Legislative Department
Seattle City Council
Memorandum

Subject: November 30, 2010 COBE Meeting: Council Bill (CB) 117014, Lowrise Multifamily Zoning

Exhibit A for 23.45.514: Height Exception for Shed and Butterfly Roofs

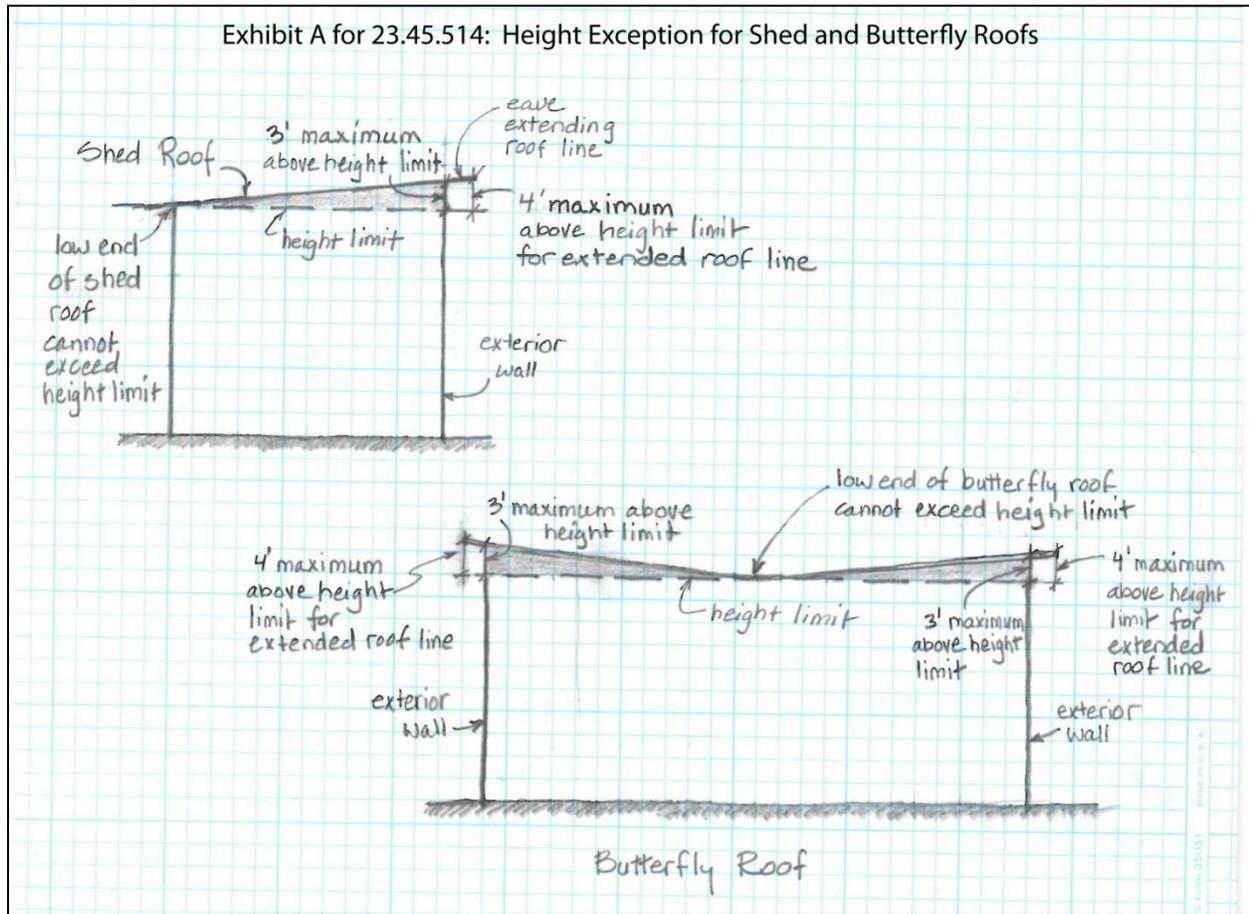
Last spring, prior to the introduction of the proposed legislation, the Committee decided not to allow a height exception for shed and butterfly roofs. Since then, public comments have pointed out that such roofs can make it easier to install solar panels. In addition, if windows are placed just under the upper side of the shed roof, they can provide light without affecting the privacy of neighboring units. When designed appropriately, eaves on shed roofs can also provide greater protection from moisture infiltration than traditional peaked roofs.

Therefore, we recommend that a new three foot height exception for shed and butterfly roofs be approved. This is less than the five foot exception allowed for other types of pitched roofs because shed and butterfly roofs can create higher walls near shared lot lines. The proposed exception would allow eaves to extend from the shed or butterfly roofs an additional one foot. A diagram illustrating how the exception would work is on the following page.

1. In LR zones, the high side(s) of a shed or butterfly roof may extend 3 feet above the height limits set in Table A for 23.45.514, provided that the low side(s) of the shed or butterfly roof are no higher than the height limit (see Exhibit A for 23.45.514).

2. The roof line of a shed or butterfly roof may be extended in order to accommodate eaves and gutters, provided that the highest point of the roof extension is no more than 4 feet above the height limit.
